Item Name: Crosstube Assembly, Mid Fwd

<b>DART AEROSPACE LTD</b>		<b>Work Order:</b>	98191
<b>Description:</b> Crosstube Assembly, Mid Fwd		<b>Part Number:</b>	D206-667-147TRN
<b>Inspection Dwg:</b> D206-667-147 Rev: A		<b>Page 1 of 2</b>

<b>DART AEROSPACE LTD</b> HAWKESBURY, ONTARIO, CANADA	
DRAWING NO. D206-667-147	REV. A SHEET 1 OF 4
TITLE CROSSTUBE ASS'Y (206L MID FWD)	SCALE NTS
COPYRIGHT © 2010 BY DART AEROSPACE LTD THIS DOCUMENT IS PRIVATE AND CONFIDENTIAL AND IS SUPPLIED ON THE EXPRESS CAUTION THAT IT IS NOT TO BE USED FOR ANY PURPOSES OR COPIED OR REPRODUCED TO ANY OTHER PERSON WITHOUT WRITTEN PERMISSION FROM DART AEROSPACE LTD.

DRAWING NO. D206-667-147	TITLE CROSSTUBE ASS'Y (206L MID FWD)	REV. A	<b>DART AEROSPACE LTD ENGINEERING ORDER</b>		D.E.O. NO. D206-667-147-A-1	SHEET NO. SHEET 1 OF 1	SCALE NTS
DRAWN <i>q</i>	CHECKED <i>ASS</i>	MFG. APPR. <i>AB</i>	APPROVED <i>MD</i>	DE APPR. <i>MD</i>			
DATE 11.07.15	DATE 11.07.20	DATE 11.07.21	DATE 11/07/21	DATE 11.07.21

**DETAIL P**  
BONDING STRAP INSTALLATION 2 PL

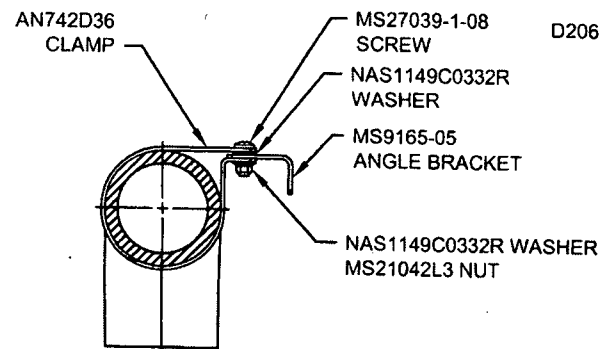
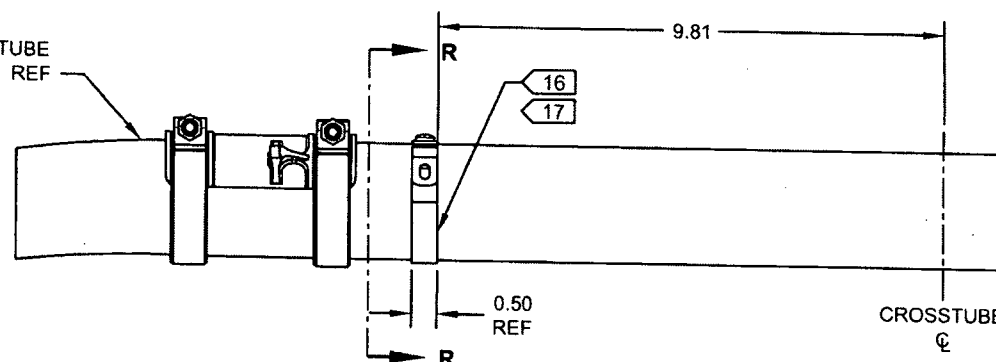
**PURPOSE:**

ADD ELECTRICAL GROUNDING STRAP

- 16) MASK AREA UNDER CLAMP PRIOR TO PAINTING
- 17) SEAL EDGES WHERE AN742D36 CLAMP MEETS WITH THE CROSSTUBE USING SIKAFLEX-241/-291 OR MIL-S-8802 CLASS B2 OR PROSEAL 890 SEALANT
- 18) PERFORM RESISTANCE CHECK TO ENSURE MAX RESISTANCE IS 10 MILLIOHMS

ITEM	QTY	PART NUMBER	DESCRIPTION
1	X	D206-667-147	CROSSTUBE ASSEMBLY (206L MID FWD)
10	2	AN742D36	CLAMP
11	2	MS9165-05	ANGLE BRACKET
12	2	MS21042L3	NUT (OR MS21042-3)
13	2	MS27039-1-08	SCREW
14	4	NAS1149C0332R	WASHER (OR AN960C10L)
